P-10945

X1500

**JINDAL ALUMINIUM LTD.**  
BANGALORE-560073 (INDIA)

PARTY'S NAME	TRELLEBORG SINGAPORE PTE LTD.,SINGAPORE
PARTY'S DRAWING No.	P-00384-L1 REV. 1
ALLOY & TEMPER	6063 T6
DESCRIPTION	MISC. SECTION

NAME	DATE
DRAWN	J.P.KAUSHIK	26-09-2017
CHECKED		
APPROVED	B.NATARAJA	06-03-2018
SCALE		1:1
AREA mm <sup>2</sup>		1997.168
PERIMETER mm.		437.398
WEIGHT kg/m		5.392
DRAWING No.	SECTION No.	
P-10945	-	
X1500	X1500(ISSUE-3)

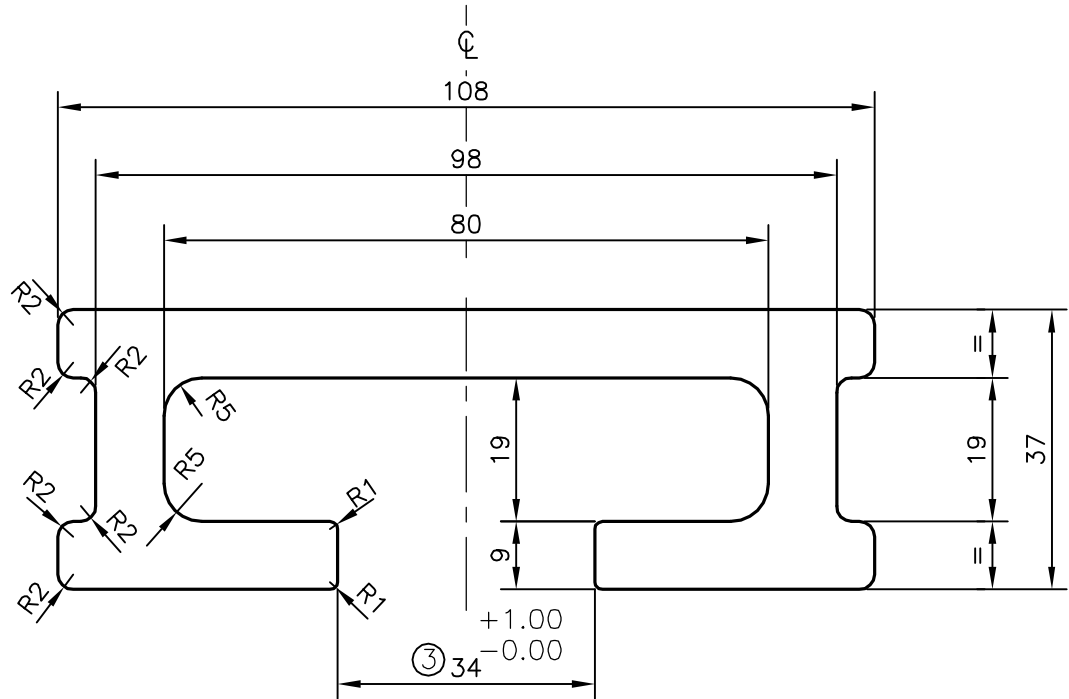
**ISSUE-2**

DIMENSION CHANGED FROM 30 mm TO 34<sup>+2.0</sup><sub>-0.0</sub>mm  
 WEIGHT ALSO CHANGED FROM 5.490 kg/m TO 5.392 kg/m

**ISSUE-3**

TOLERANCE CHANGED ON DIMENSION FROM 34.0<sup>+2.0</sup><sub>-0.0</sub> TO 34.0<sup>+1.0</sup><sub>-0.0</sub>
